# Portage Bridge Cycling Improvements

PUBLIC CONSULTATION REPORT

**Figure 2. Cross-section of Option 1: bidirectional cycle track widened to 3 metres with an additional 0.5-metre buffer**

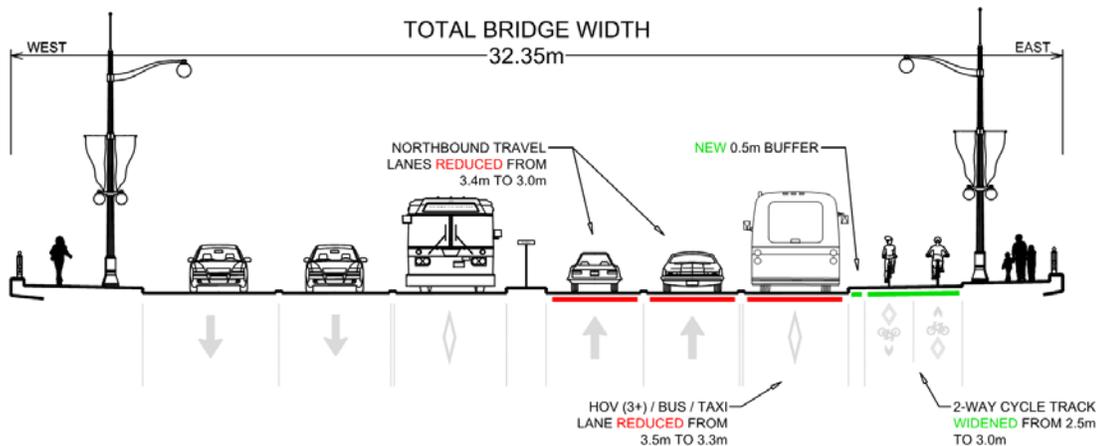
Survey respondents were generally supportive of Option 1, with 66% of respondents indicating that they would be more likely to cycle on the Portage Bridge with a widened two-way cycle track. However, many cyclists indicated that Option 1 would only be a marginal improvement over existing conditions. A number of respondents commented that they would remain uncomfortable without a barrier, stating the proximity to buses, wind drafts, and a fear of falling into the vehicle lane as the reasons. Others commented that they generally dislike bidirectional cycle tracks and would prefer unidirectional cycle tracks (Option 3).

- Pave the cycle track in asphalt rather than concrete.
- Make the division between the cycle track and the sidewalk a 45° slope to allow cyclists to exit the cycle track when necessary.
- Add the reflective plastic pole lane dividers on the buffer between the cycle track and vehicle lanes.

**Figure 3. Cross-section of Option 2: bidirectional cycle track widened to 2.6 metres, with an additional 0.25-metre-wide barrier and new 0.5-metre shoulder**

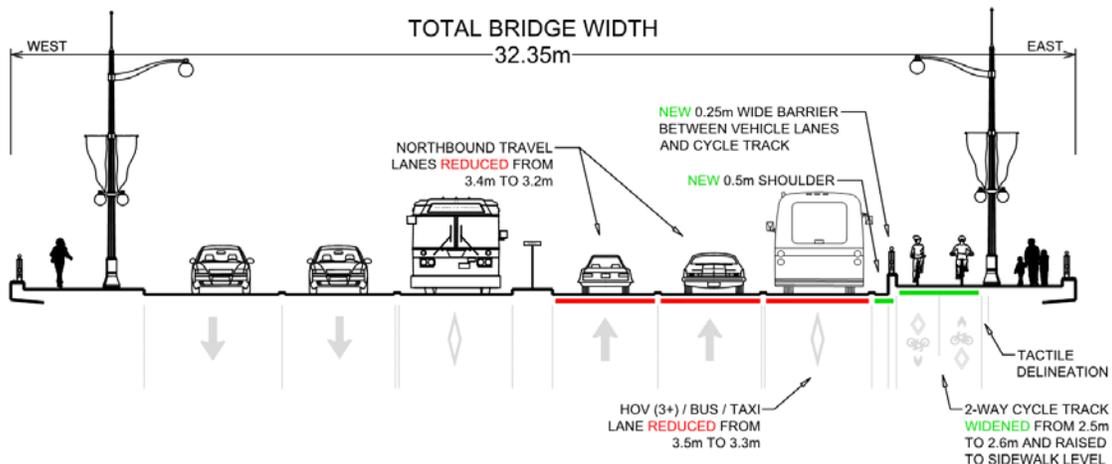
Respondents were equally supportive of Option 2 as they were of Option 1, with 66% of respondents indicating that they would be more likely to cycle on the Portage Bridge with a barrier between the vehicle lanes and cycle track. Many were enthusiastic about the safety improvements that a barrier would bring to the cycle track, and stressed that Option 2 would make it easier for tourists and families to use the facility.

Some respondents expressed concerns about specific aspects of Option 2. These included comments about the existing cycle track feeling too narrow, prompting concern that a new barrier without widening would make it feel even narrower. A related concern was the new risk of hitting a bicycle’s handlebars on the barrier. Other respondents did not like that the new cycle track would be at the same level as the sidewalk, which they felt would increase the potential for cyclist-pedestrian conflicts on the bridge. While not opposed to Option 2, some respondents were unsure why the vehicle lanes could not be narrowed to 3.0m to both widen the cycle track *and* provide a barrier.

- Ensure the barrier is tall enough such that cyclists do not fall over it into vehicle lanes.
- Ensure the barrier is an adequate distance away from the cycle track at handlebar height.

**Figure 4. Cross-section of Option 3: unidirectional cycle tracks**

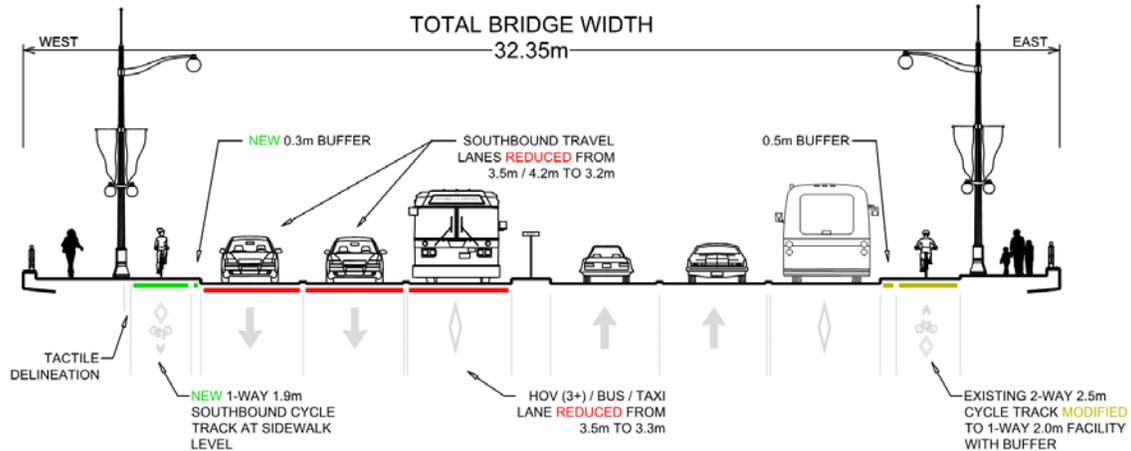
Option 3 received less support than either Option 1 or Option 2, with only 50% of respondents indicating that they would be more likely to cycle on the Portage Bridge with unidirectional cycle tracks. Option 3 enjoyed strong support from commuter cyclists and frequent users of the bridge, many of whom indicated they already cycle southbound on the west side of the bridge (either in the vehicle lanes or on the west sidewalk). The main concern of respondents regarding Option 3 was how connections would be made to the pathway network. Several respondents indicated that their support for Option 3 was contingent upon the improvement of connections on both sides of the bridge.

- Make the cycle track on the west side of the bridge bidirectional from Victoria Island to Gatineau.
- Add a barrier to both unidirectional cycle tracks.
- Add a connection from the Voyageurs Pathway to the proposed southbound cycle track on the west side of the Portage Bridge.
- Replace the path with stairs near the Mill Street Brew Pub with a bicycle friendly ramp for southbound cyclists.
